City of Chelsea Planning Commission

AGENDA

Tuesday, August 15, 2023 at 7:00 PM

**Site Plan Approval
for
City of Chelsea, Michigan**

Title
LANDSCAPING PLAN

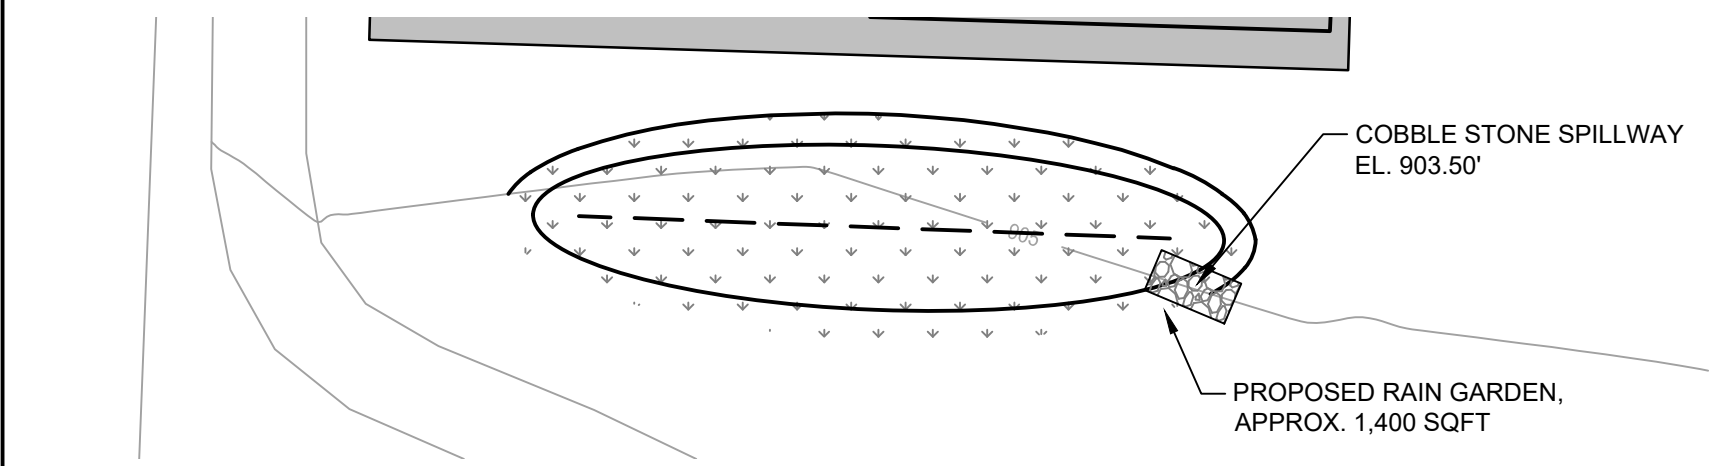
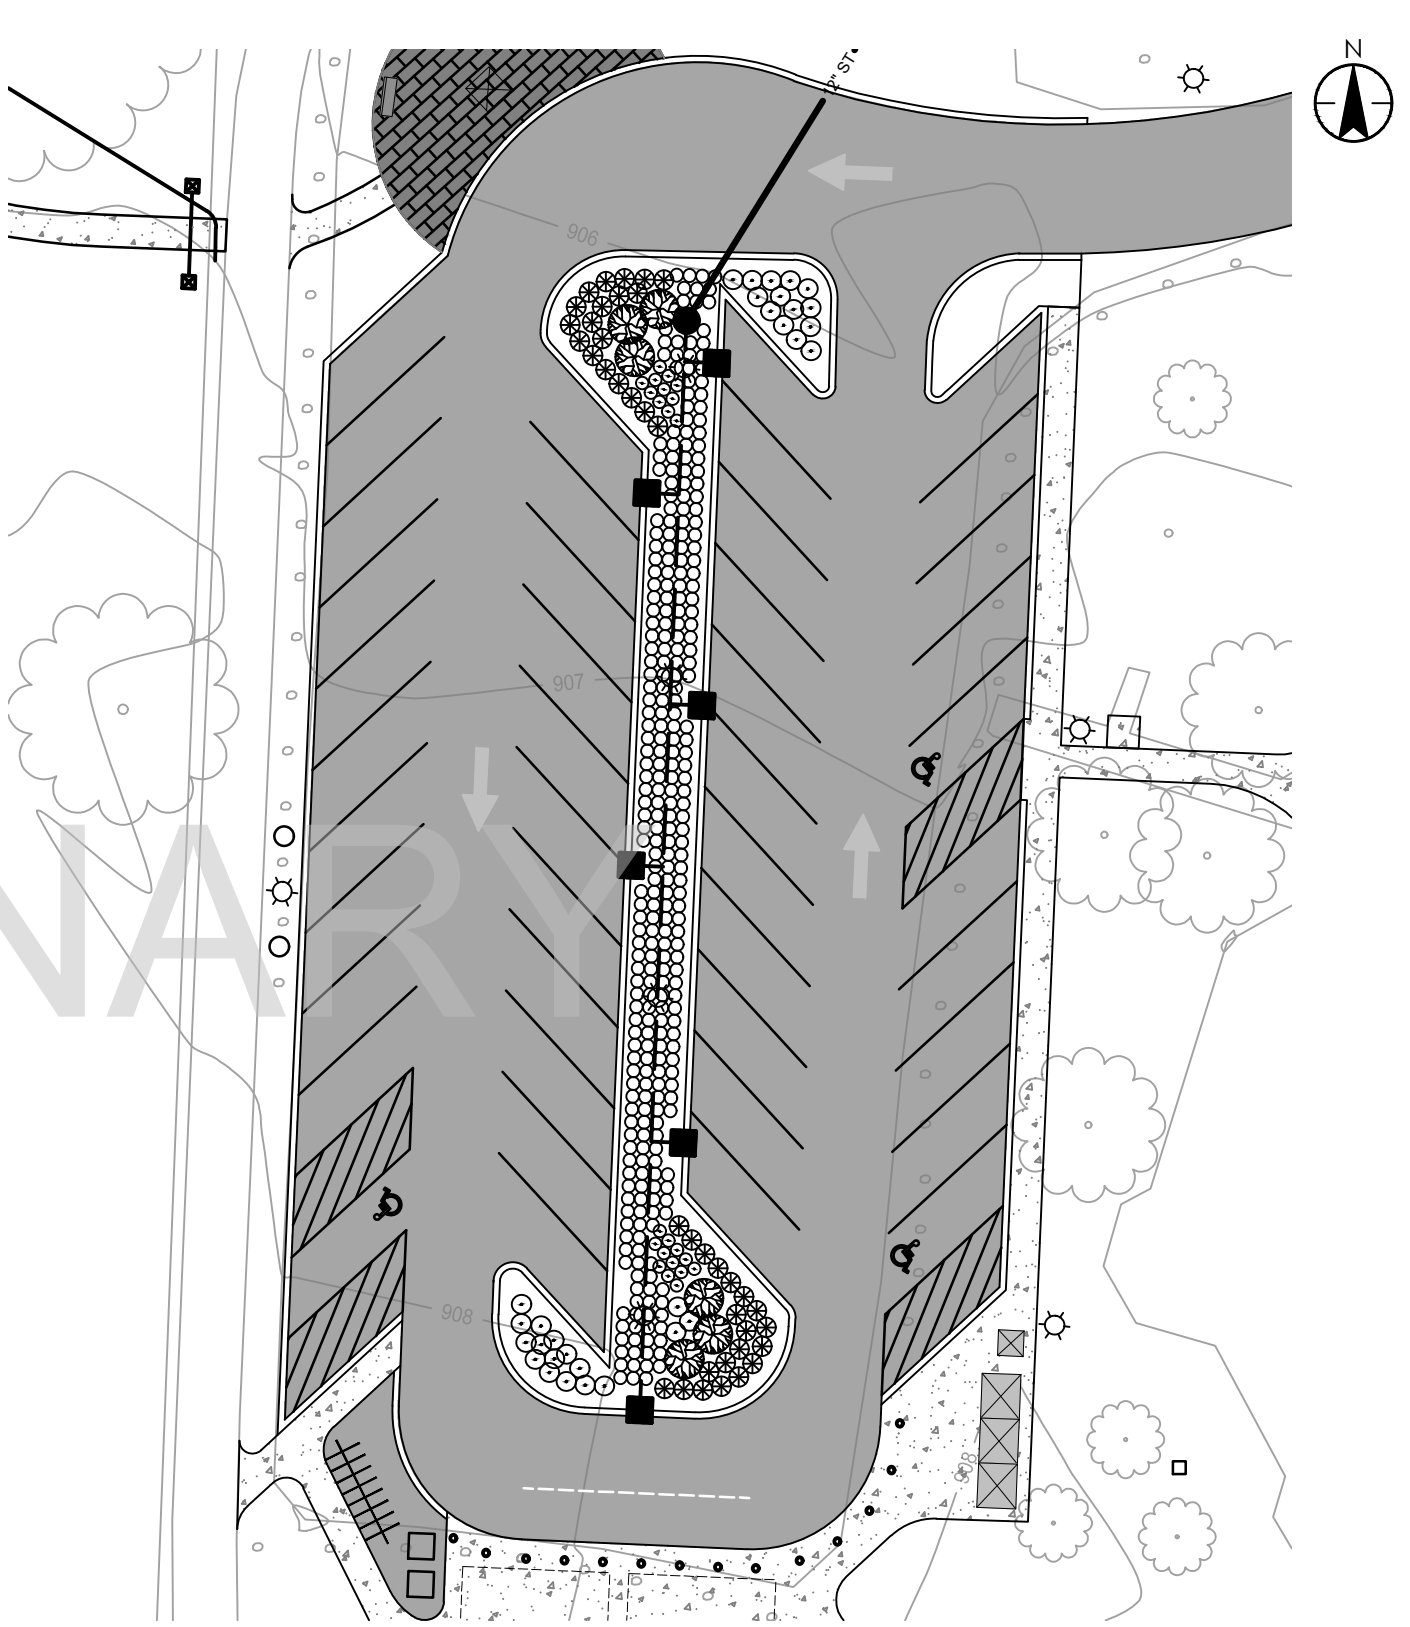
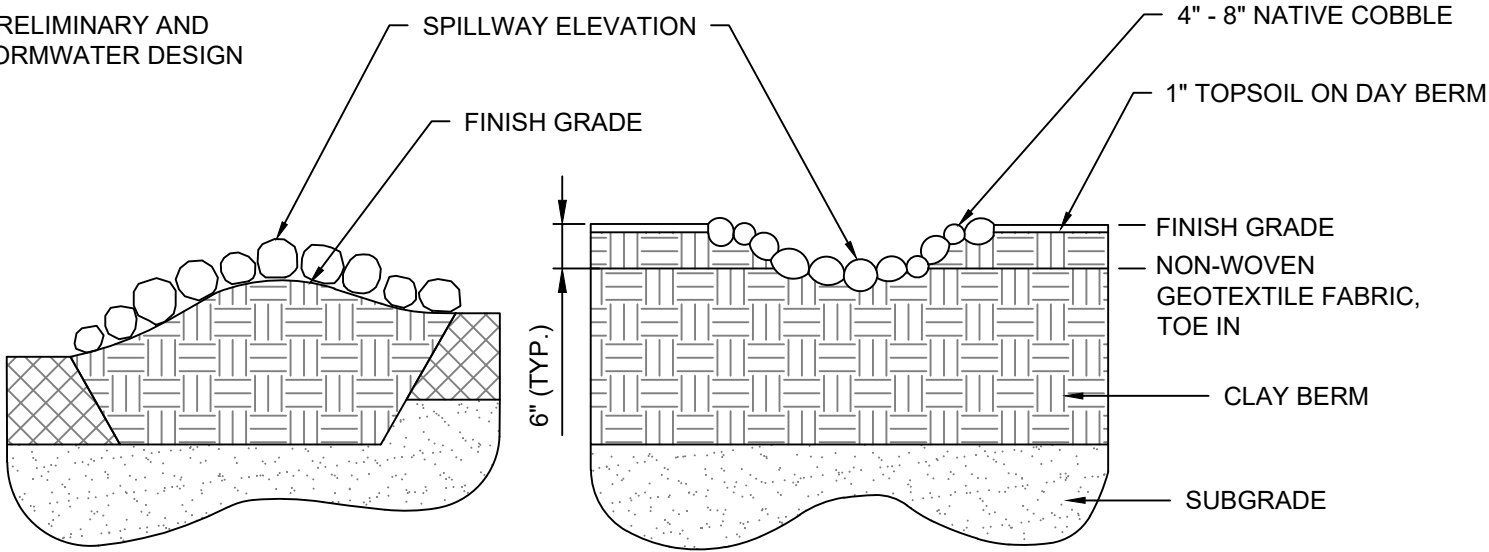
The location of the project on the property allows for the area to be well screened by existing trees on all sides of the project. The applicant has included a tree removal plan on sheet 8 and a landscaping plan on sheets 13 and 14. There are proposed trees around the perimeter of the parking lot and within the parking lot islands. There are also substantial planting proposed within the rain gardens. The plan indicates that four (4) trees will be removed: two (2) from the south side of the parking area and two (2) from the east side.

Two rain gardens are proposed. The rain garden to the south of the pickleball courts will be 1,400 square feet, and the rain garden to the north of the parking area will be 4,500 square feet. The applicant has indicated that 204 total shrubs and 863 total perennial and ornamental grasses will be planted throughout both rain gardens and the landscaped parking lot island.
